Access Compliance Report Public Rights-of-Way (Curb Ramps)

Main Street: CLOVERDALE Cross Street: CASTLETREE Location: SE

ADA ID: RPRK211018151707 Ramp Type: Type 1 - Perpendicular Diagonal Initial Pass/Fail: Fail Overall Compliance: No Severity Score: 30

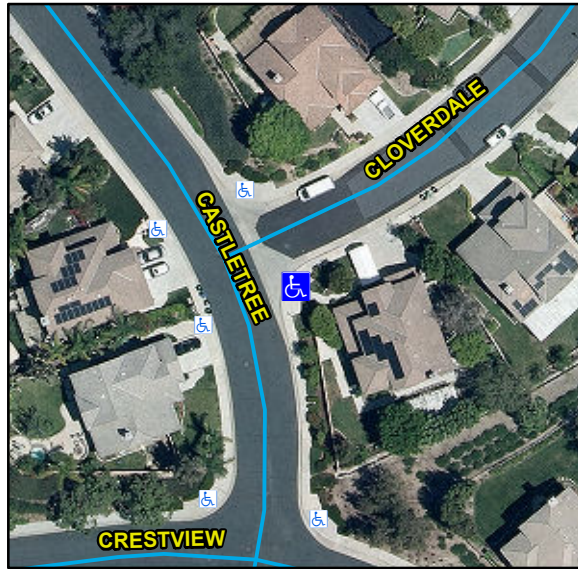
Compliance	Description	Data	Compliance	Description	Data
N/A	Ramp Length (in)	66	N/A	Flare Type LT	
Yes	Ramp Width (in)	48			N/A
No	Ramp Run Slope (%)	13.7	N/A	Flare Slope LT (%)	N/A
Yes	Ramp Cross Slope (%)	1.3	N/A	Flare Traversable LT	N/A
N/A	Landing Present	N/A	N/A	Flare Type RT	
N/A	Landing Length (in)	N/A			N/A
N/A	Landing Width (in)	N/A	N/A	Flare Slope RT (%)	N/A
N/A	Landing Run Slope (%)	N/A	N/A	Flare Traversable RT	N/A
N/A	Landing Cross Slope (%)	N/A	N/A	DWS Provided	N/A
N/A	Landing Movement Obstructed?	N/A	N/A	DWS Contrast	N/A
	Landing Movement Type	N/A	N/A	DWS Length (in)	N/A
N/A	Landing Shared	N/A	N/A	DWS Full Width	N/A
N/A	Clear Space	Yes	N/A	DWS Offset Left (in)	N/A
N/A	Clear Space To Crosswalk (in)	N/A	N/A	DWS Offset Right (in)	N/A
N/A	Marked Crosswalk 1	No	N/A	Marked Crosswalk 2	No
	Crossing 1 Direction	N		Crossing 2 Direction	W
	Marked Crosswalk 1 Width (in)	N/A		Marked Crosswalk 2 Width (in)	N/A

N/A	Ramp Inside Crosswalk 1	N/A	Yes	Ramp Inside Crosswalk 2	N/A
	Crossing 1 Slope (%)	1.2		Crossing 2 Slope (%)	2.9
	Crossing 1 Cross Slope (%)	5.4		Crossing 2 Cross Slope (%)	4.3
N/A	Gutter Ponding	N/A	N/A	Curb Slope	4.1
No	Gutter Lip Height (in)	0.25		Road Run Slope (%)	1.7
N/A	Gutter Run Slope (%)	N/A		Road Cross Slope (%)	3.8
N/A	Gutter Cross Slope (%)	N/A			
Yes	Overall Surface Condition: Acceptable		No	Perp Joint Present	No
	Cross Gutter Present?	Yes		Spandrel Present?	Yes
	Replace Cross Gutter?	No		Replace Spandrel?	No

Remove & Replace Curb Ramp With Two New Directional Ramps or Equivalent. Grind Gutter Lip.
